DESIGN REVIEW/CERTIFICATE OF APPROPRIATENESS APPLICATION

One Church Parking Lot Addition
GAHANNA, OHIO

APPLICATION STAFF COMMENTS

Project/Property Address or Location: 817 North Hamilton						
Project Name/Business Name: One Church						
SUBMITTED BY: Name: Michael Blackford	Title: Deputy Director					
Department: Planning and Development

CERTIFICATE OF APPROPRIATENESS
SITE PLAN

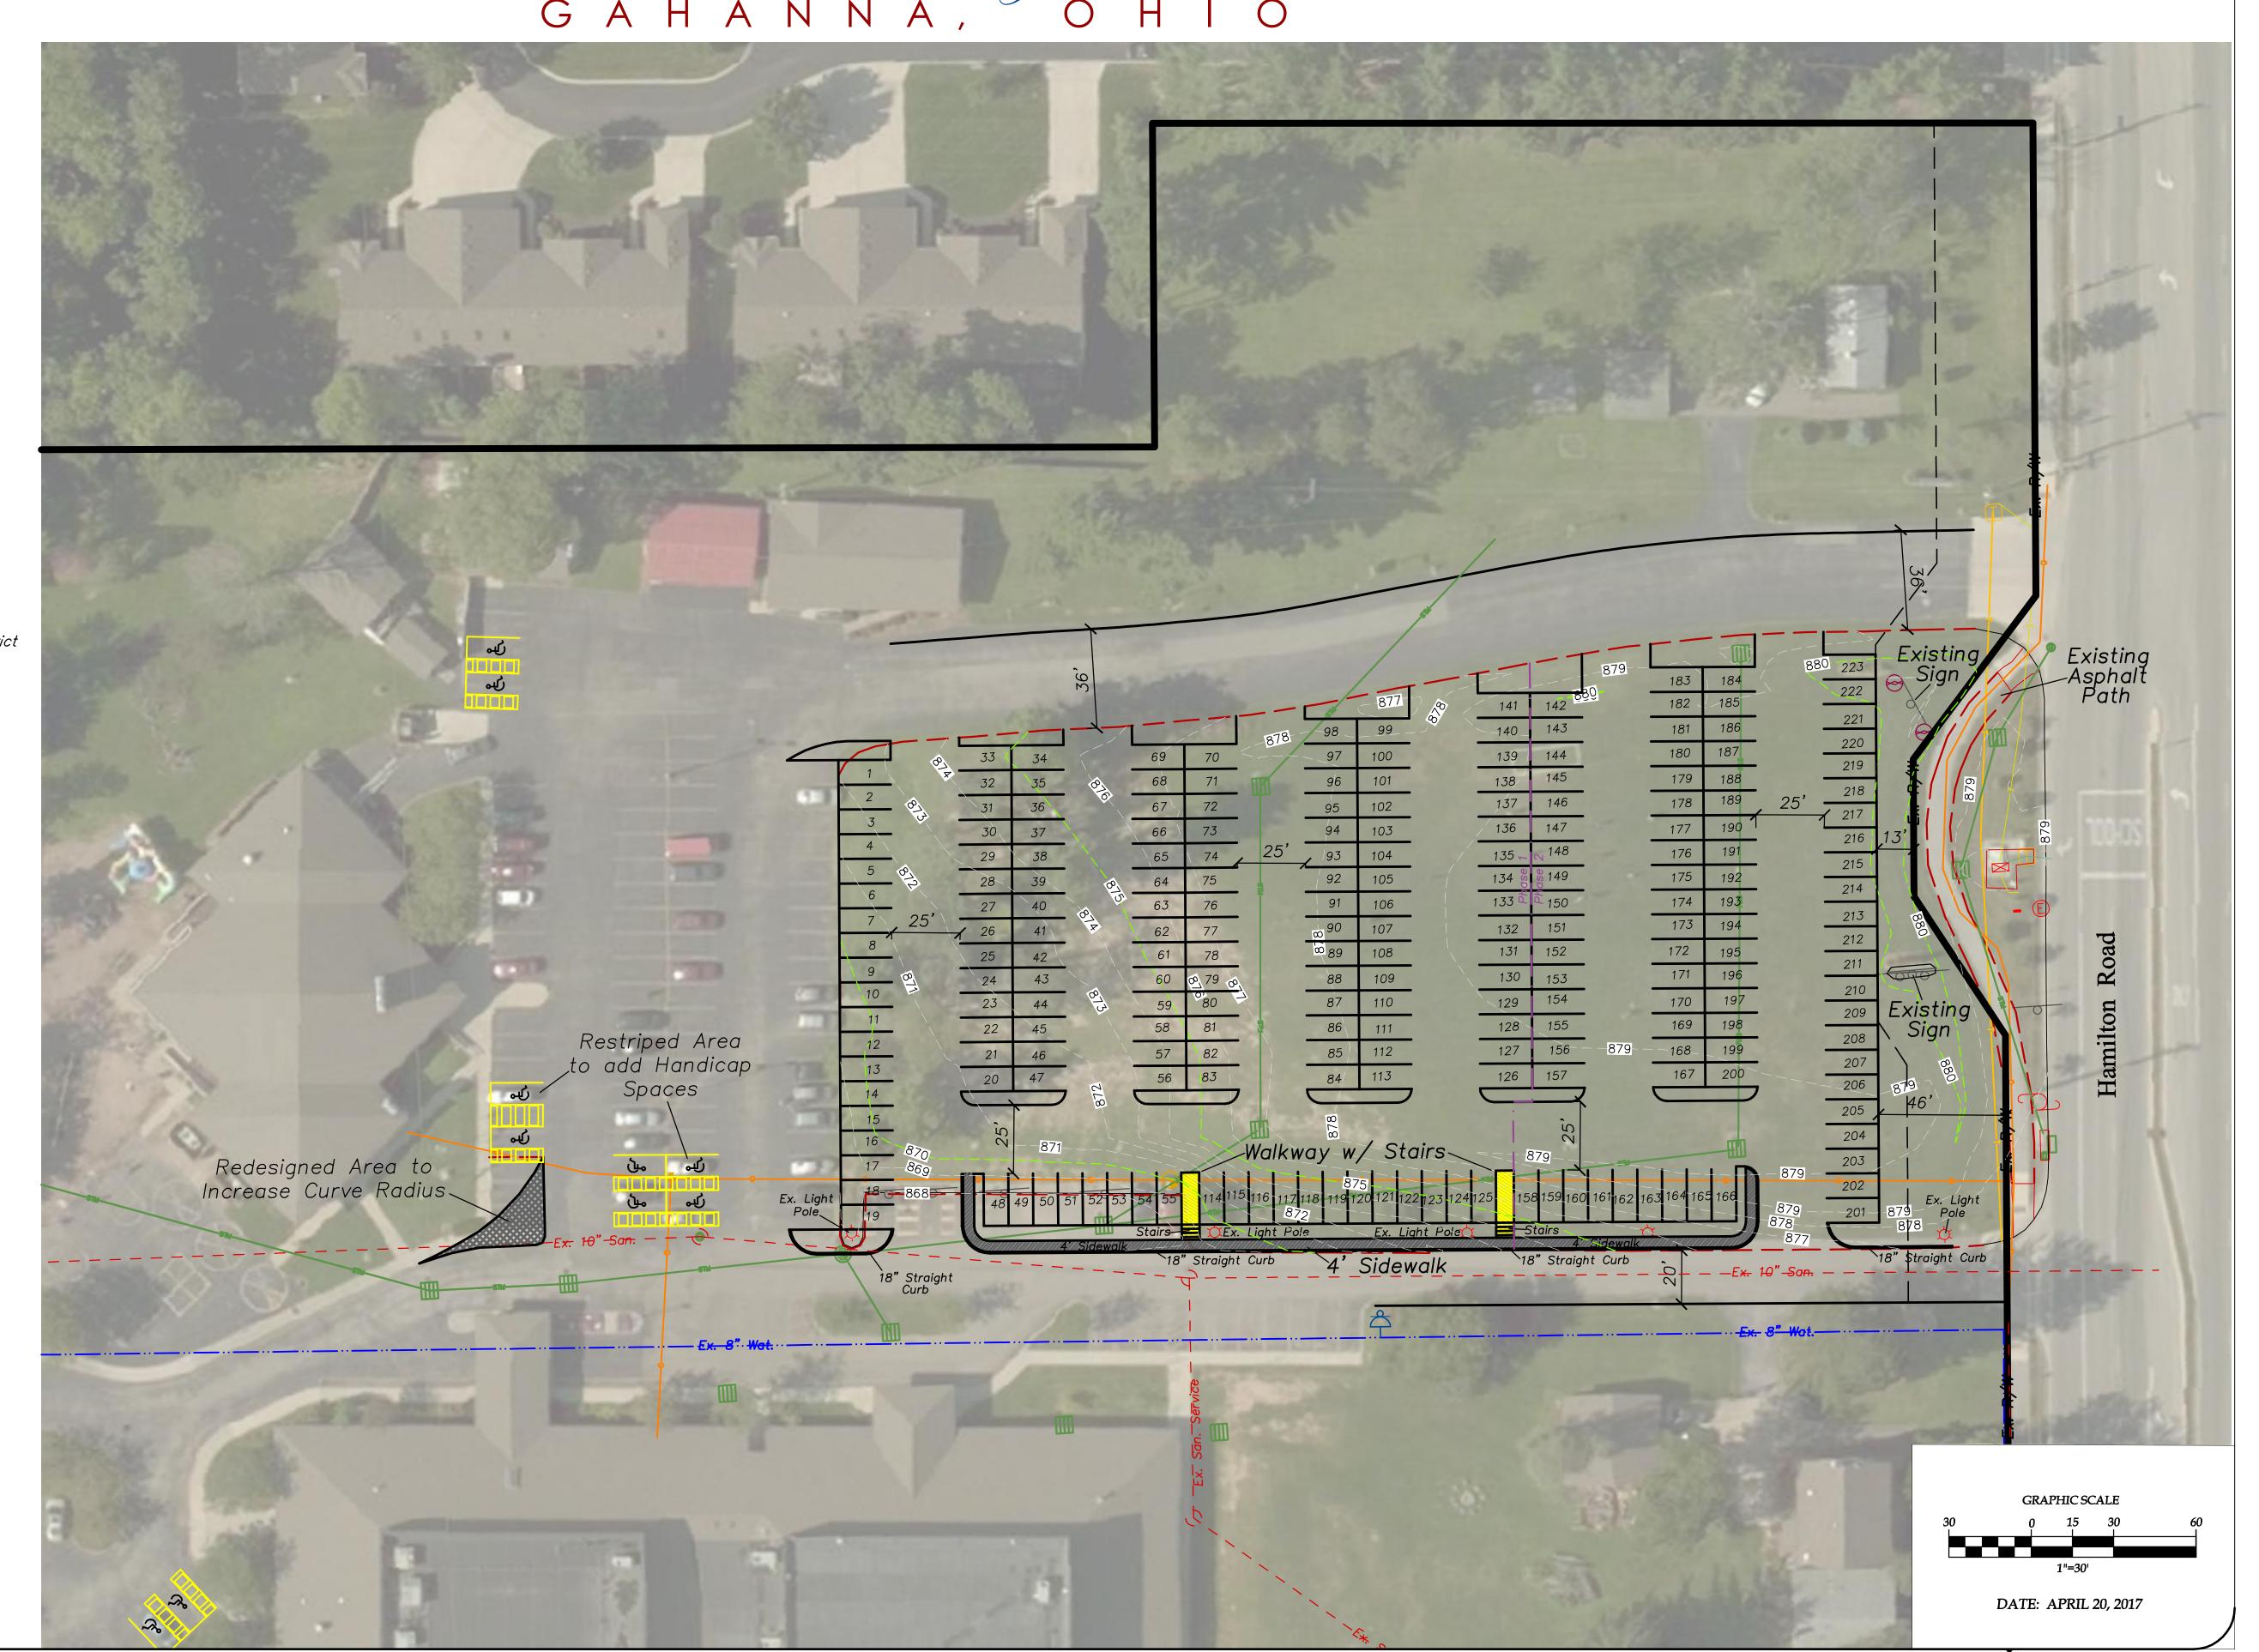
It is Planning and Development staff's opinion that the request as submitted does not meet the standards of DRD-3. The proposal is for one large parking area consisting of 223 spaces on approximately 1.5 acres of pavement. The Code encourages smaller, individual parking areas. Possible compromises to a redesign may include increased screening along Hamilton Road and/or pervious pavers, additional tree islands, or other green infrastructure initiatives.

Staff concurs with the applicant that a special condition exists due to the right-of-way bump out along Hamilton Road. A cursory review of the area indicates that this is the only such bump out. Therefore, staff finds that there is a special circumstance. Additionally, it appears that the edge of pavement of Hamilton Road is consistent, meaning the light from the parking area should not create an unsafe condition as it is setback the same distance as other lights from the road.

The proposed parking lot does have adequate driving lanes to allow for fire apparatus access and there are at least 2 ways into the parking lot. The fire division is ok with the parking lot improvements,

The ROW jogs to the west right in front of the church property, and in order to add a row of parking in this area, the setback is reduced to 13' at the pinch point.
